File 1993-0023

Name: Ptarmigan Ridge - Filing 6 - West of 27 1/2 Rd. at Cortland Avenue

Final Plan & Plat
Ptarmigan Ridge North, Filing #6

Revised plans for Filing 6 were received on April 5, 1993. After review of these plans, following are the comments:

Ptarmigan Ridge filing #6
Revised 5-18-93

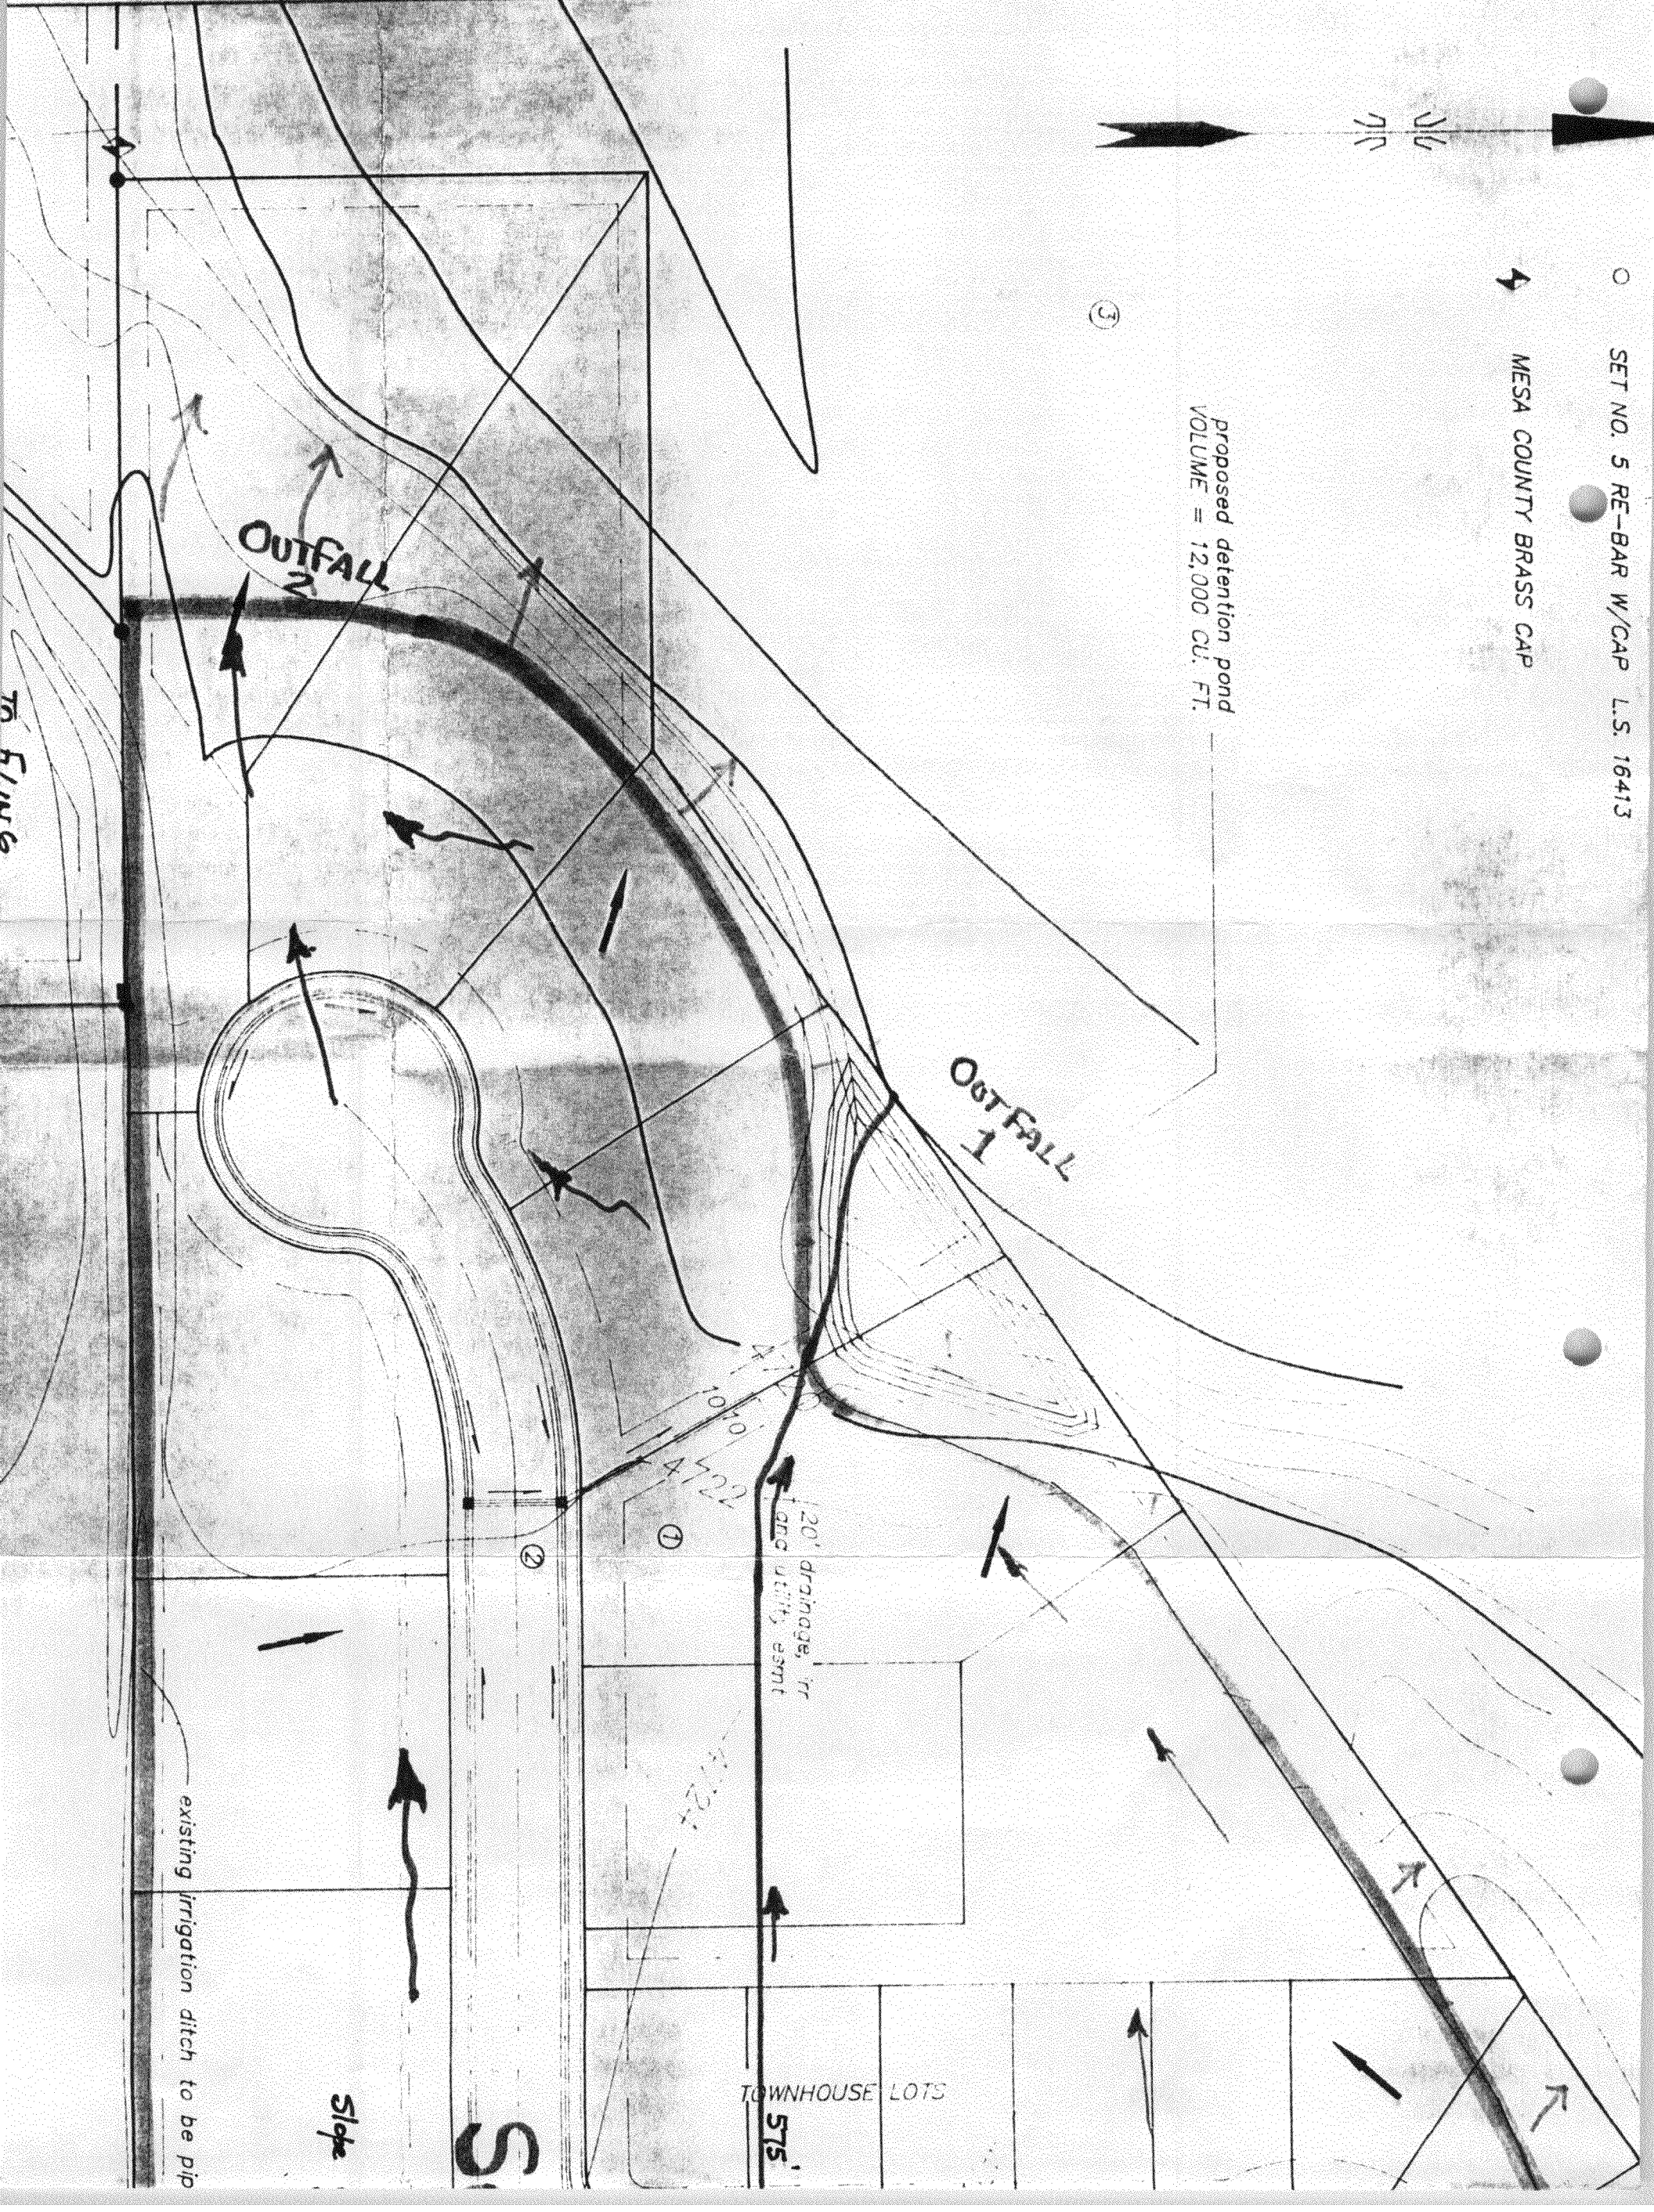
4. That notation be required on the final plan which includes restrictions of the 44 ft. utility/irrigation/drainage/pedestrian easement located between North 15 Street Court and Cortland Court including the following statements:

- a. No structures, fences shall be constructed nor the planting of trees and shrubs shall be allowed within this easement.
 - b. Drainage within this easement shall be constructed and maintained so that all run-off within the easement is contained within the easement.

8. The petitioner shall provide a profile and details for the gravity overflow pipe between the irrigation pond and storm detention basin prior to recording the plat.

9. Handicap curb ramps are required and should be shown at all street intersections. Horizontal curve data, including the beginning and ending stations and offsets (or coordinates), are required on the plans for all curves along the perimeter of the streets, including cul-de-sacs and intersection radii. This information is needed for layout and staking of the street improvements.

10. Vertical P.I.s and other points shown on the street profiles need to be labeled or otherwise identified. Gutter grades on Ren Court and Cortland Court should be increased above 0.5%. The south half of the drainage cross-pan at station 9+11.19 is shown to be flat on the street profile (flowline elev. 4719.74) and will not drain and therefore must be modified.

11. On the drainage plans, the inlet grate and frame specified is incorrect. The number should be Castings IFG-3246-CI. The type and class of PVC drainage pipe must be specified. The sidewalk thickness shall be shown on section A-A. Provide details/literature for "Kerf" grating specified on top of drainage structure. The concrete box must be notched to hold grating in place.

Proposed detention pond
VOLUME = 46,841 CU. FT.
SEE IMPROVED FOR DETAIL

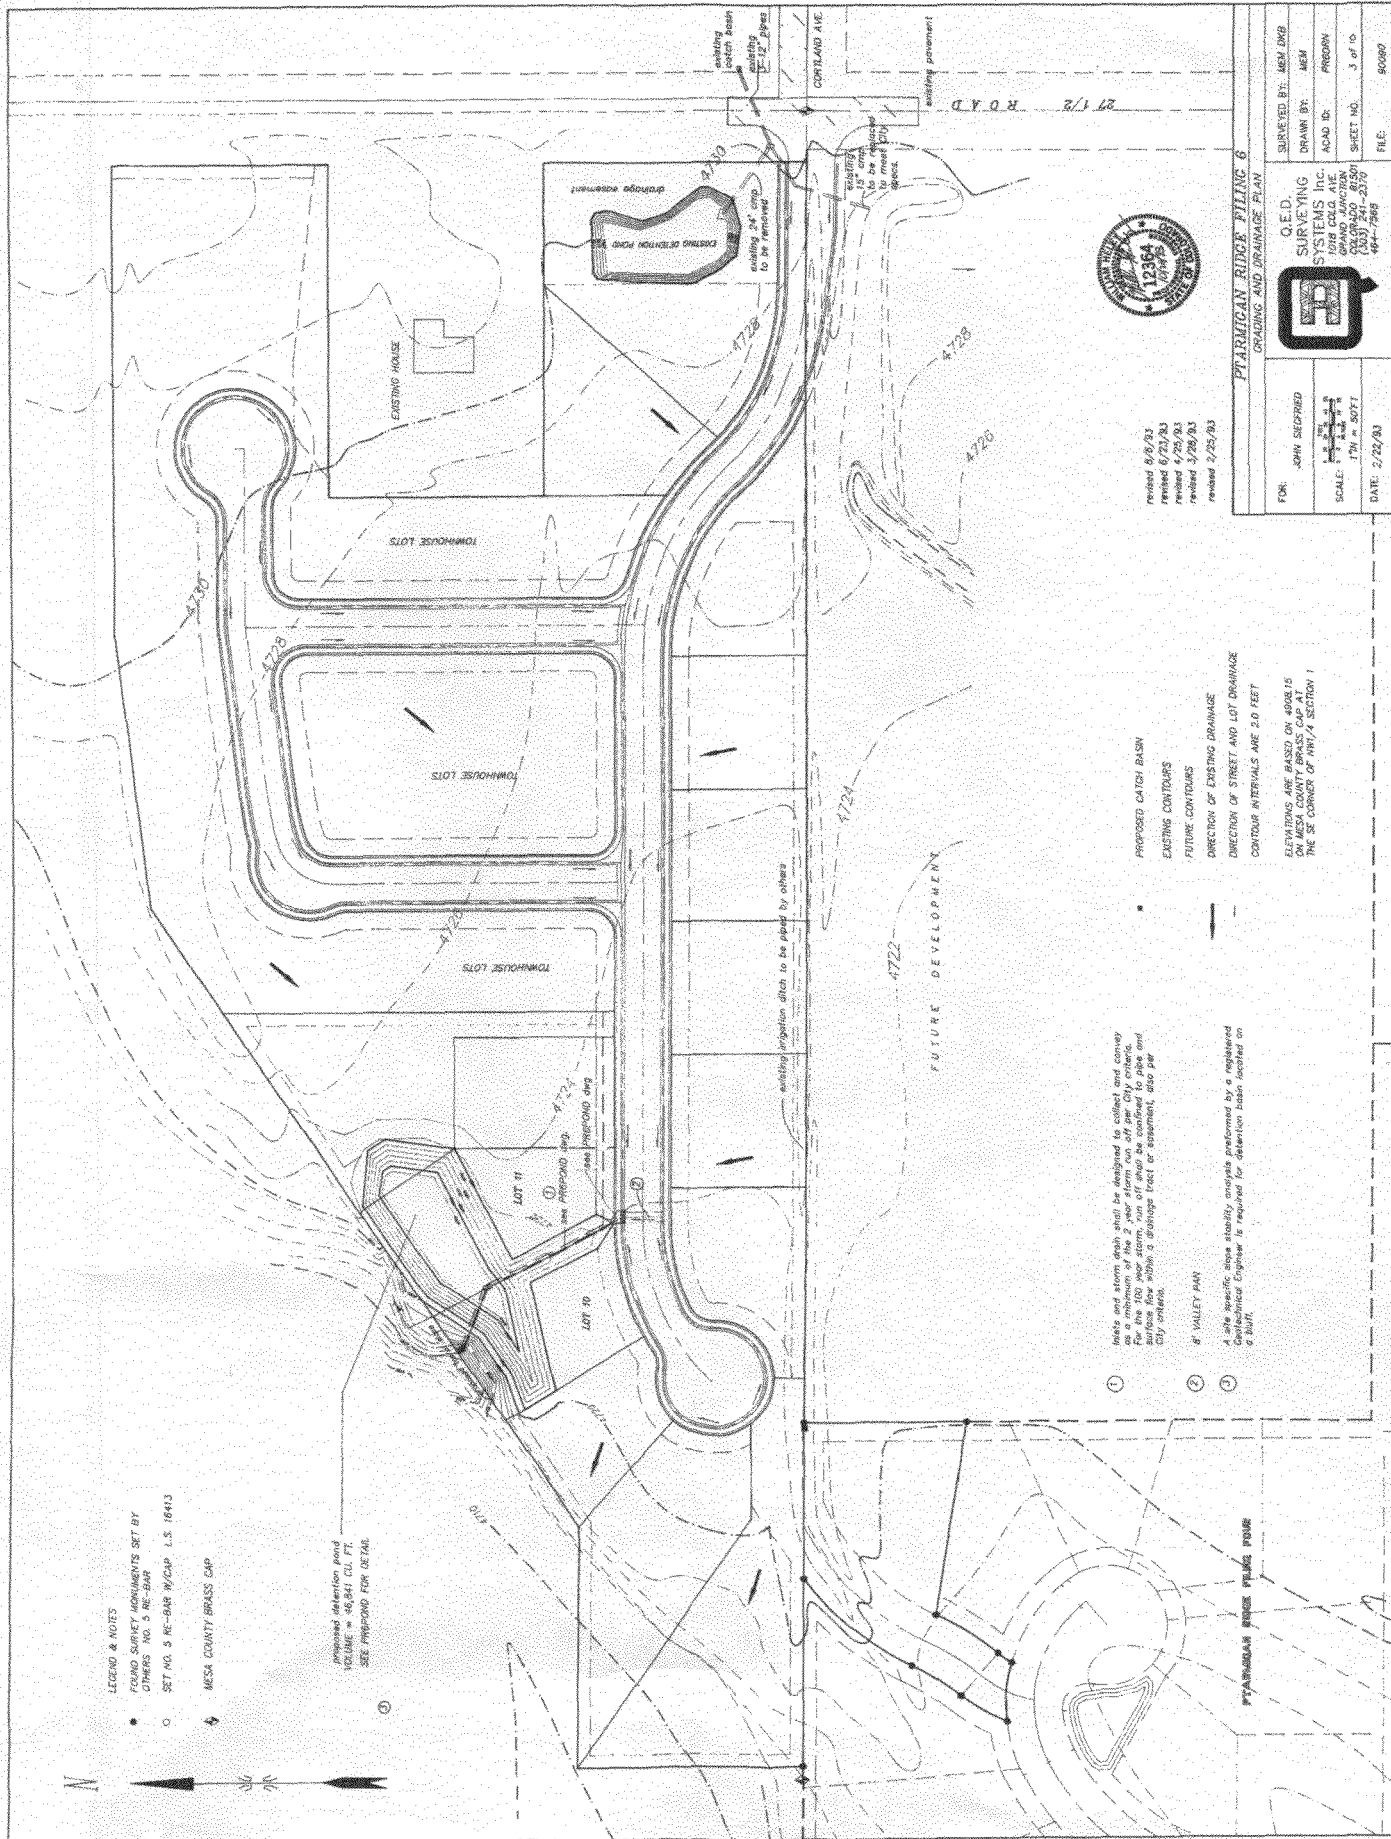
1. Side Slopes: The slopes of the detention pond must be constructed as shown on sheet 9 of the approved construction drawings. Please note that the 4720 contour, which is 0.75 feet above the high water line, is designed to be located on the easement line along lots 11 and 13. The sides are to be at a uniform slope of 4:1.

The grading plan shown on Sheet 3 of the drawings shows the 4722 and 4724 contours outside of the drainage easement on lots 11, 12 and 13. Therefore the slopes of the detention pond extend beyond the easement boundary in order to intersect the ground surface. Where the slopes extend beyond the easement line, they must be uniformly graded to match the 4:1 slopes located inside the easement. The grading plan is available in my office and should be shown and explained to the lot owners. I would encourage you to explain to them why the slopes must extend outside of the easement.

4. The overflow drainage channel between lots 10 and 11 needs to be moved east approximately 2' to the location shown on sheet 3 of the approved drawings. The plan shows the channel centered within the easement; the channel needs to be constructed as shown. Due to site conditions the ends of the channel cannot be relocated but the balance of the drain way must be constructed per plan.
